### APPEAL SUMMARY

**Appeal ID:** 19041

**Project Address:** 631 SE Taylor St

**Building/Business Name:** The Rose Apartments

1-HOUR RATED OPERABLE  
WINDOWS WITH FUSIBLE  
LINKS  
APPEAL ITEM #5

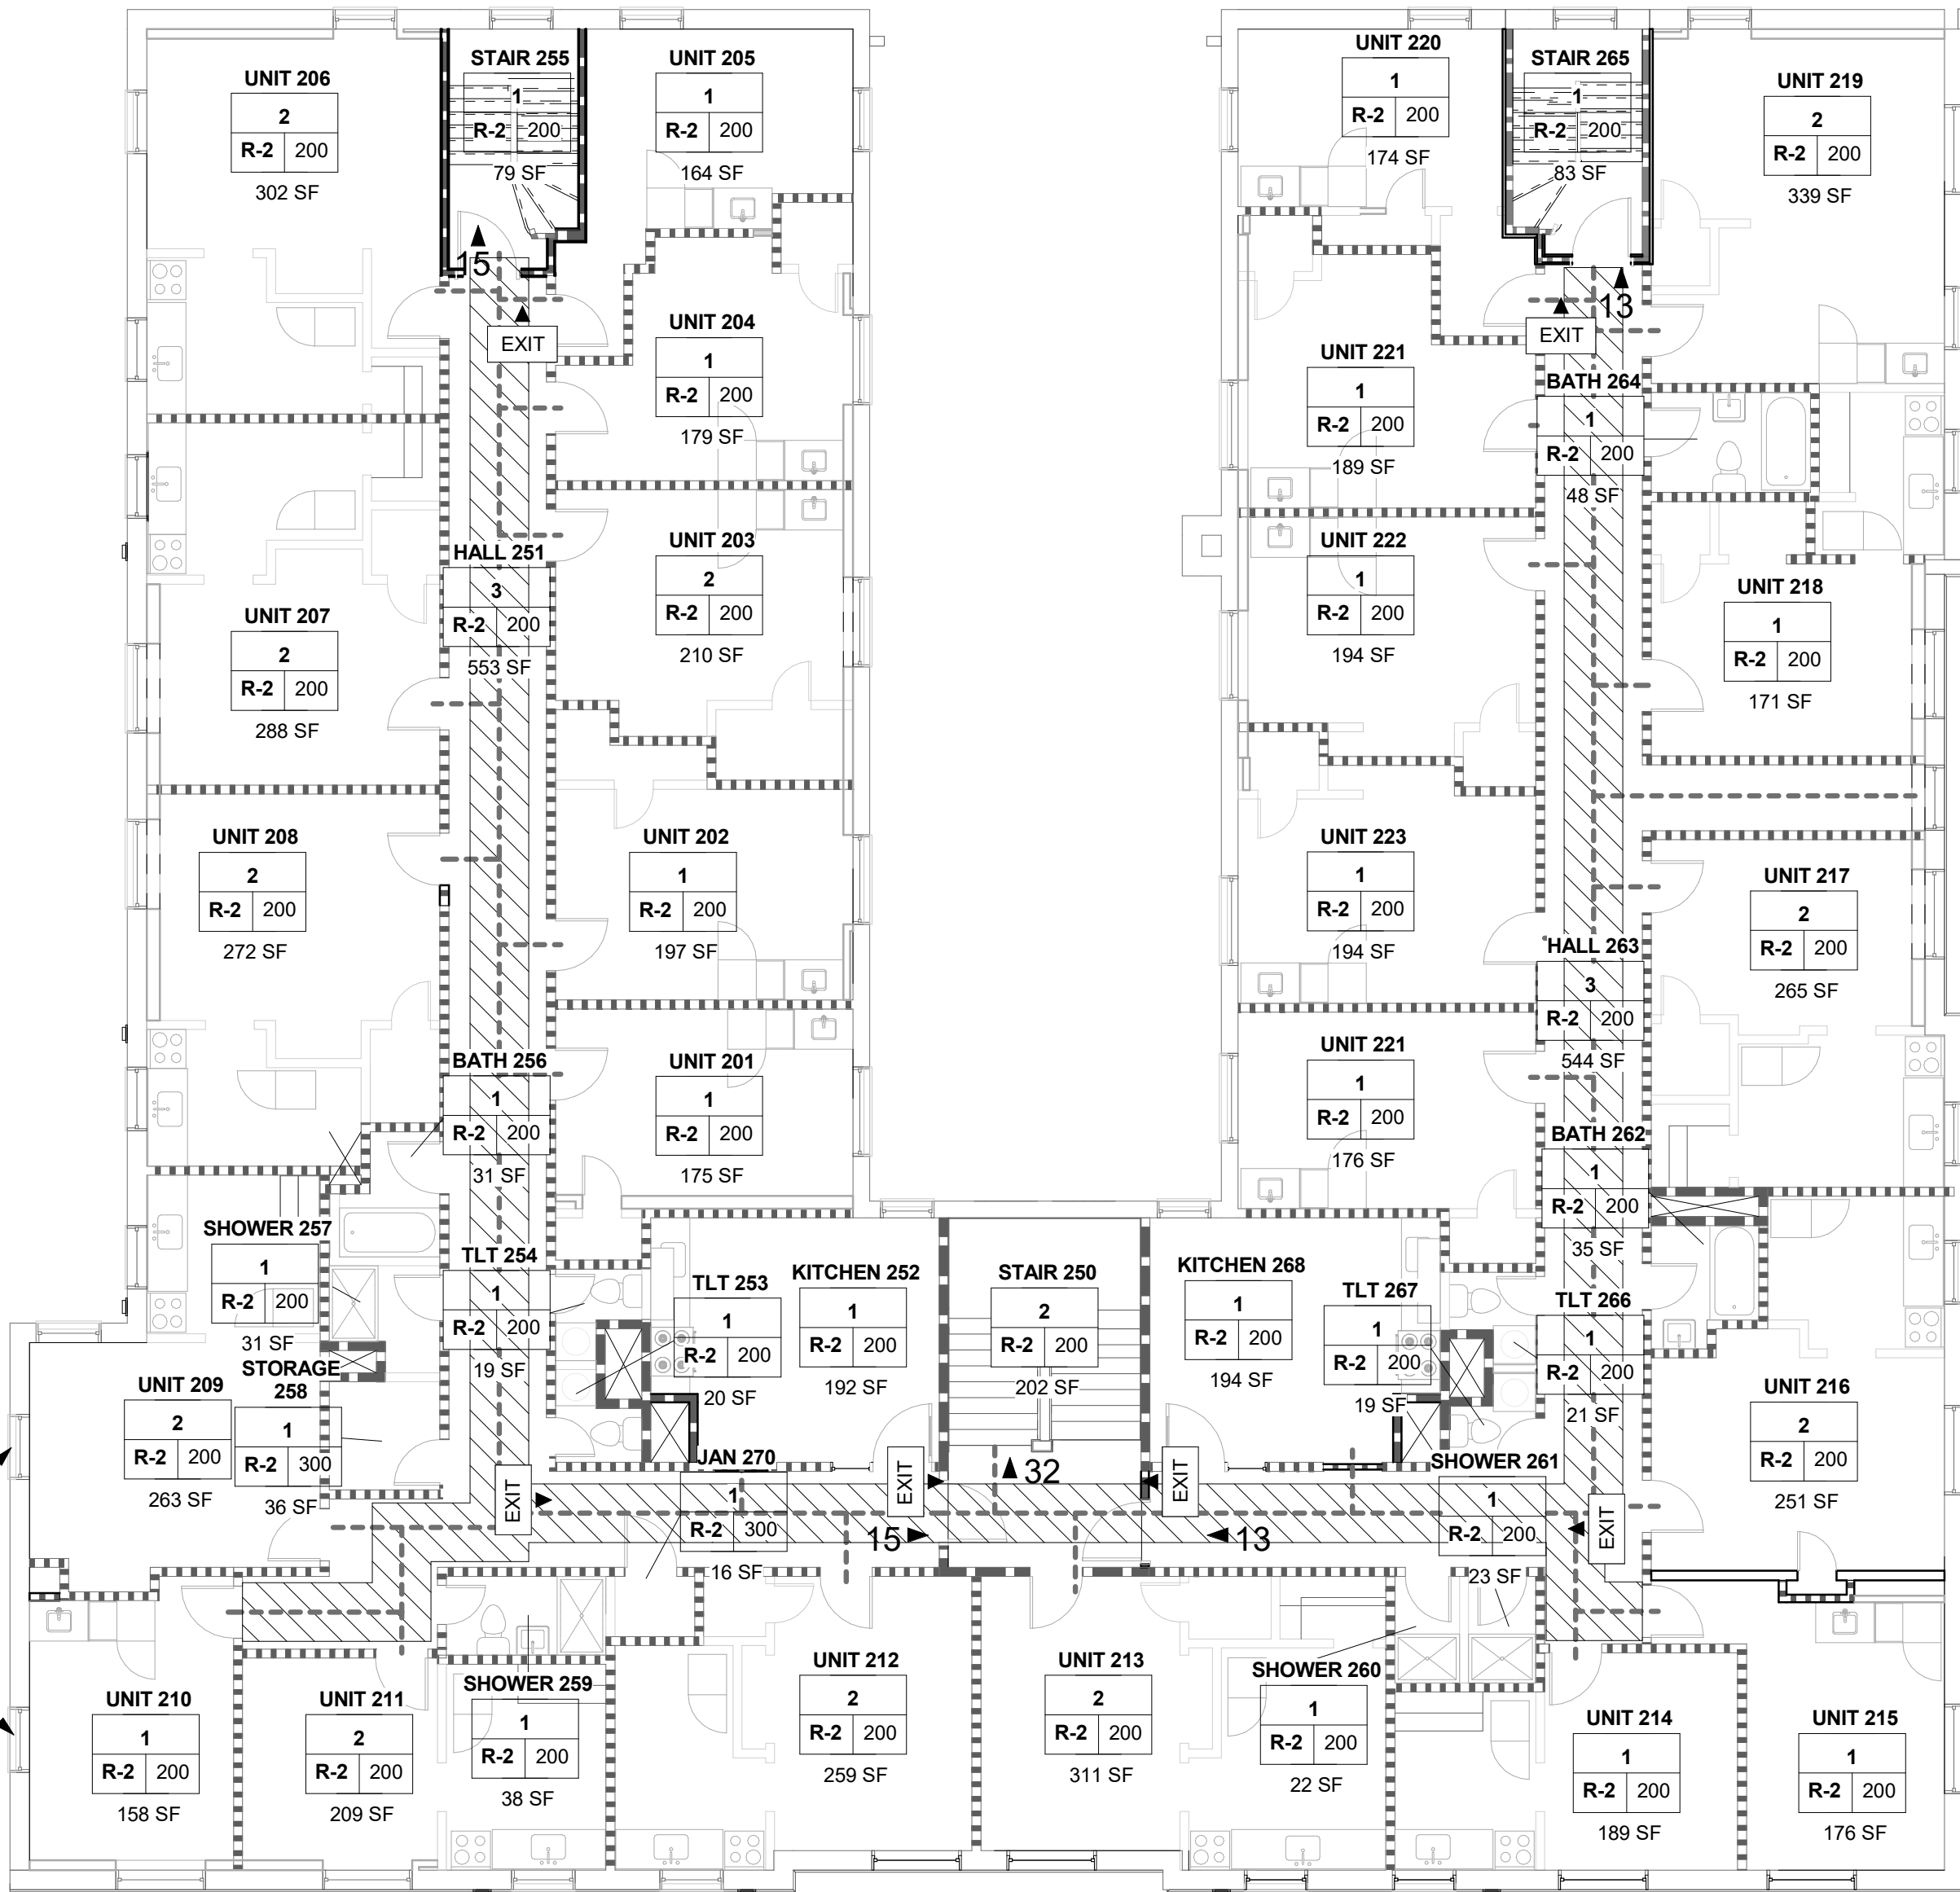
There is one existing ground story non-rated operable window along the western portion of the egress court (Unit 105). This window was approved by Appeal #6358. This window will be replaced with a UL listed ¾-hour fire-rated operable window with a fusible link that closes the window in the event of a fire. There are two existing ground story non-rated operable windows along the eastern portion of the egress court (Kitchen 124 and Food Pantry 123). These windows were approved by Appeal #6358. These windows will remain and be fixed in place, with additional sprinkler protection provided on the interior side. See Sheets GA2 and GA3.

<b>Code Section</b>	Table 705.8 Allowable Openings Based on Fire Separation Distance
<b>Requires</b>	Unprotected openings less than 3' from a property line are not permitted.
<b>Proposed Design</b>	<p>ORIGINAL APPEAL TEXT: The six unprotected operable windows at the west property line shall remain. The building shall be equipped with a full NFPA 13 sprinkler system throughout. See GA2 and GA3.</p> <p>RECONSIDERATION TEXT: The six unprotected operable windows at the west property line shall be replaced with UL listed 1-hour fire-rated operable windows with a fusible links that close the windows in the event of a fire. The building shall be equipped with a full NFPA 13 sprinkler system throughout. See GA2, GA3 and GA5.</p>

**1. Type 13 water curtain sprinkler protection at non-fire rated openings in exterior walls of egress court less than 10' in width: Granted provided windows are non-operable and sprinklers are spaced not more than 6 feet apart and placed a minimum of 6 inches and a maximum of 12 inches from the opening(s) and a maximum of 12 inches below the ceiling. Sprinklers are to be installed on the occupied side of the openings. A separate permit from the Fire Marshal's Office is required.**

**4. Proposed UL listed 1 hour fire rated operable windows with self closing mechanisms at property line: Granted as proposed.**

GA4

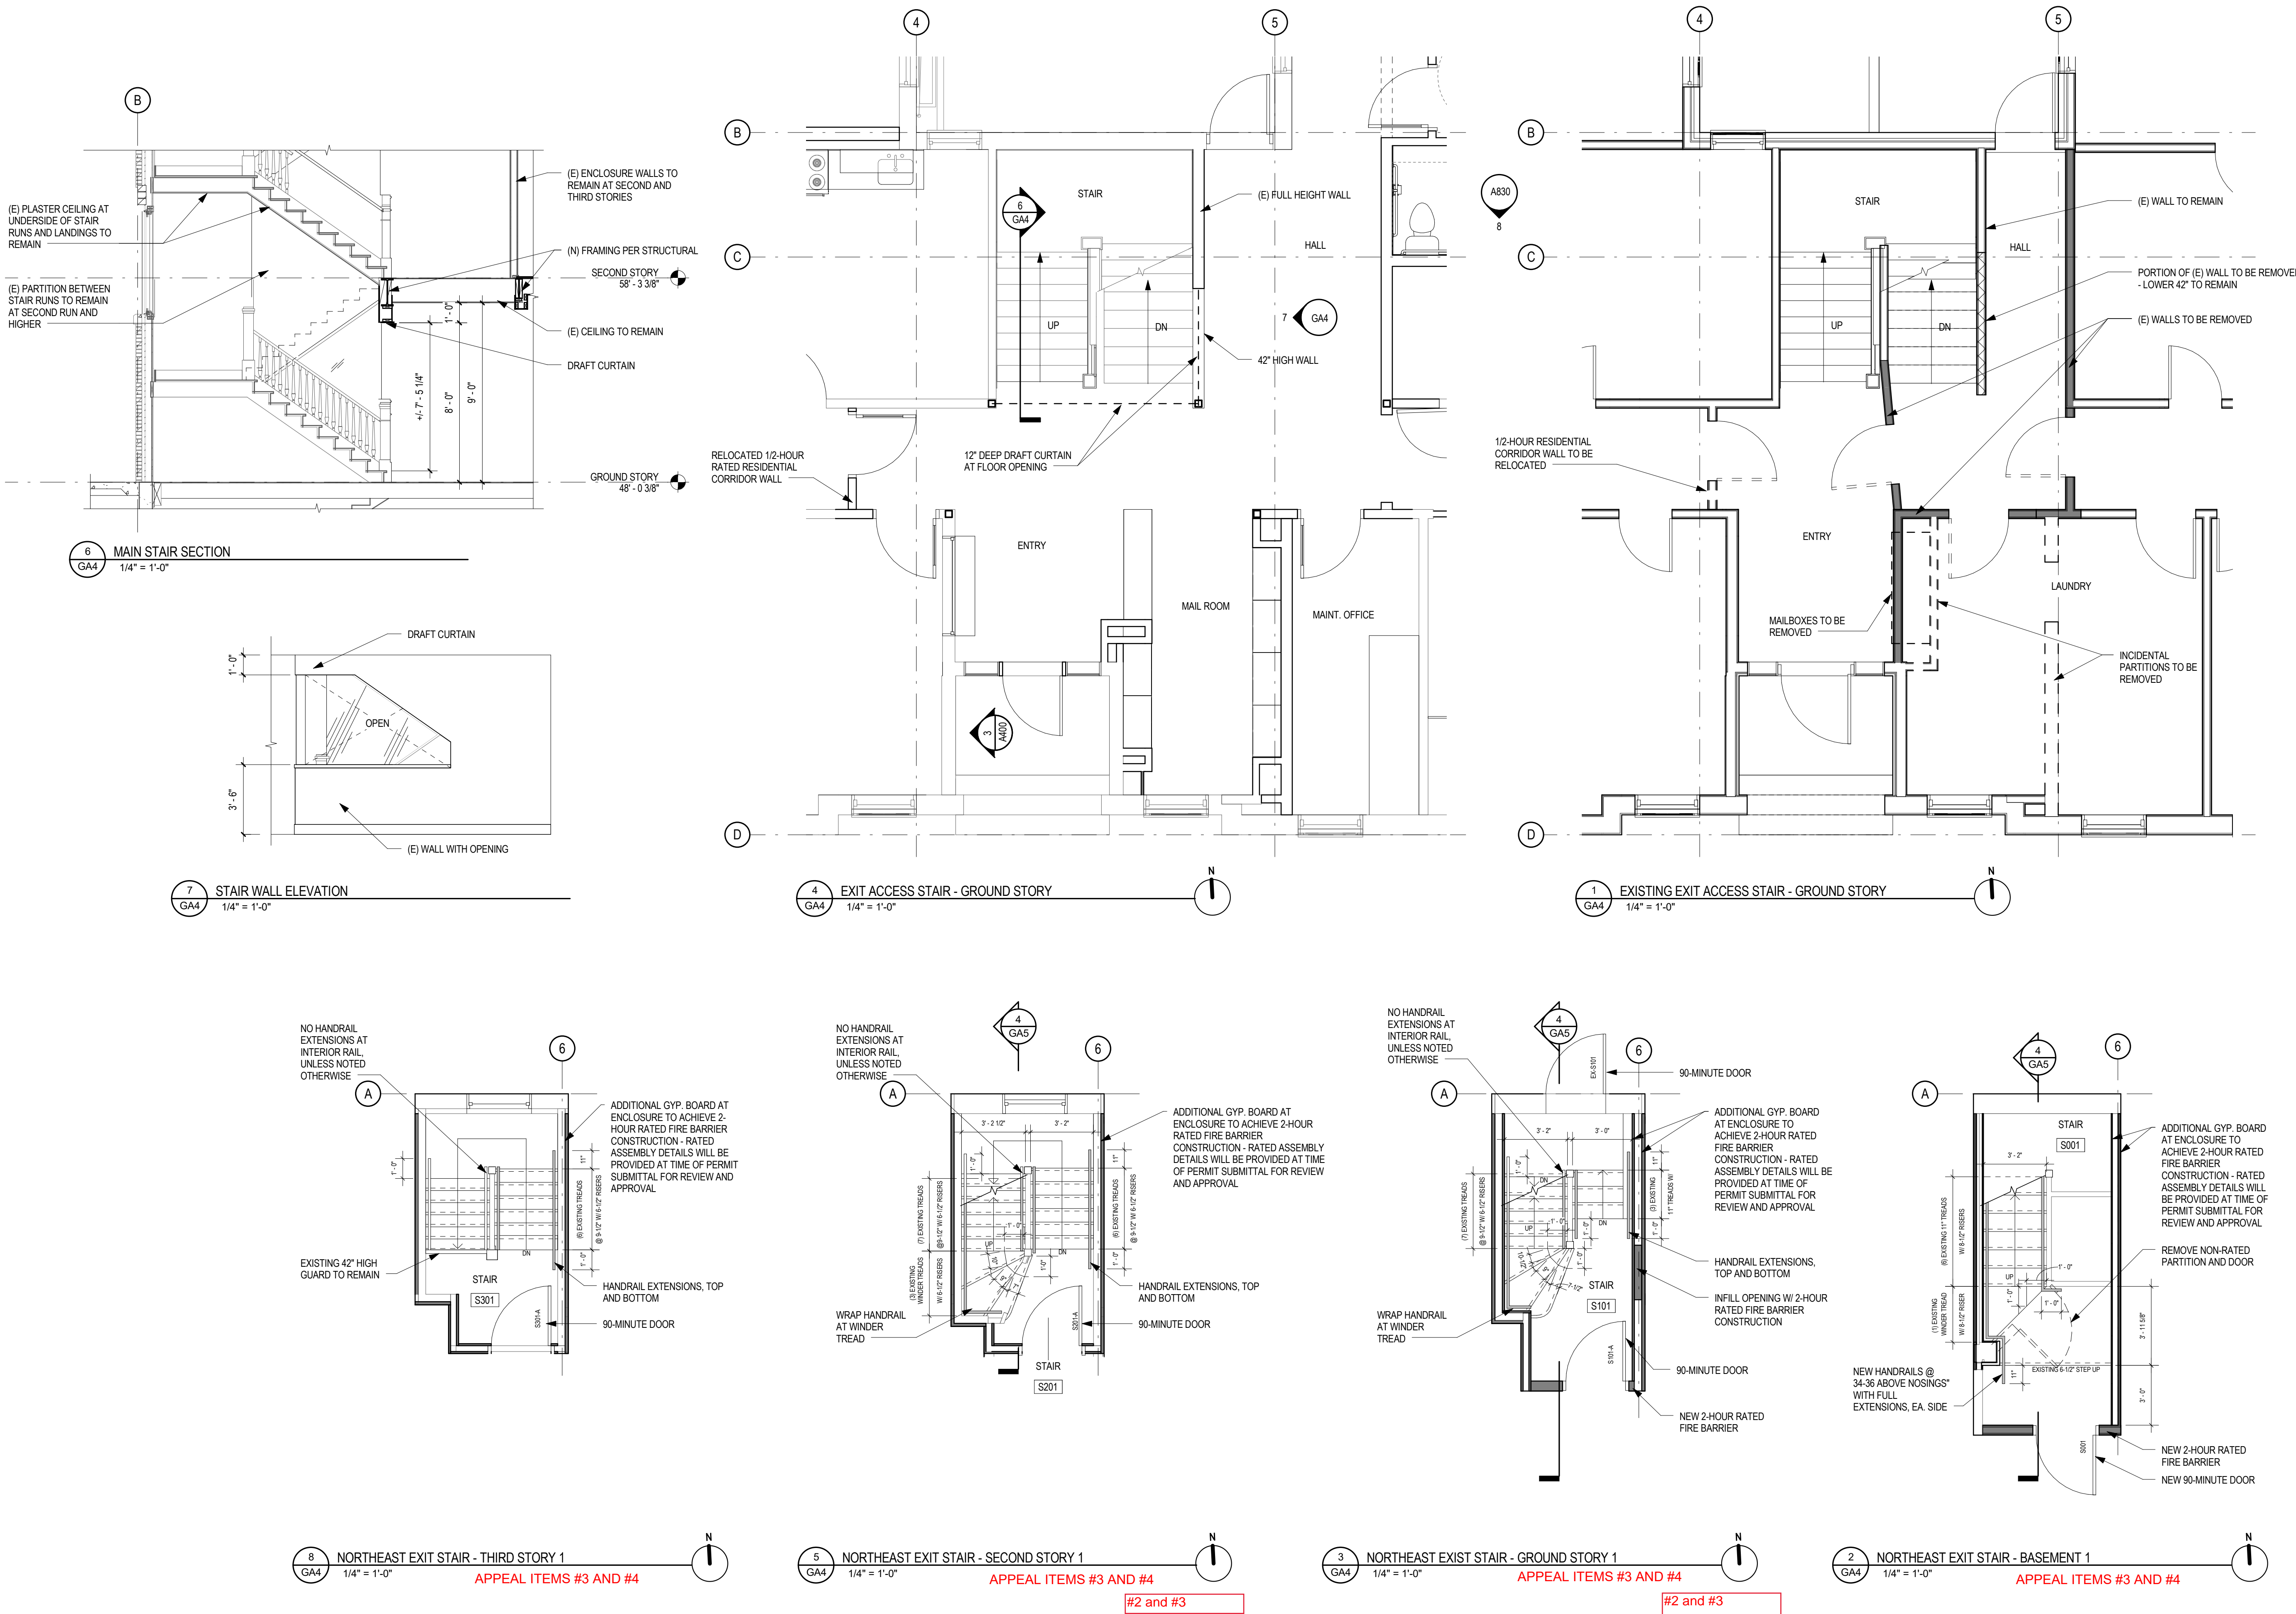
**Proposed Design** ORIGINAL APPEAL TEXT: The existing winder treads in northeast and northwest stairs will remain. These have been approved by previous appeals dated 8/8/74 and 1/27/88. The exit stair enclosures will be repaired to achieve the required 1- and 2-hour construction. New rated doors will be provided. New lighting to meet the requirements of Section 1006 will also be provided within the stair enclosures. See Details 2, 3, 5 and 8/GA4.

See Details 2, 3, 5 and 8/GA4, and Details 1, 2, 3 and 5/GA5.

**2. Winder treads in 2 egress stairs: Granted as proposed.**

**3. Omission of handrail extensions in 2 egress stairs: Granted as proposed.**
